SIB 11 09 21

## RECALL 21V-907: EXHAUST GAS RECIRCULATION (EGR) COOLER – N47T HIGH TEMPERATURE

This Service Information Bulletin (Revision 3) replaces SI B11 09 21 **dated May 2022**.

### What's New (Specific text highlighted):

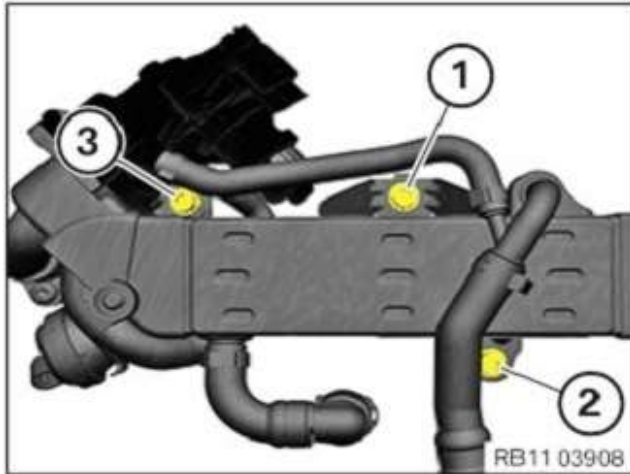
- Remove the EGR pipe from the intake venturi pipe (replace O-ring (2) and gasket (3)).

- Inspect and clean (if needed) the EGR pipe. Wear protective equipment (eyes and hands) and clean out the excessive carbon using a degreasing agent and a brush (suitable brushes can be found in wheel brush kit 83 19 2 298 237).
- Reinstall the EGR pipe with new gasket and O-ring before installing the new EGR cooler.
- Install the new EGR cooler following the repair instructions.

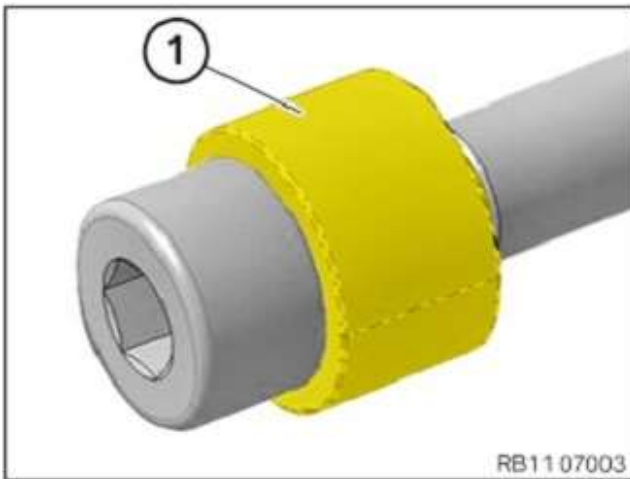
- Inspect highlighted screws before reusing.

- Replace the screws if they do not have the 10mm spacer (1). Use PN 07 14 9 886 429.
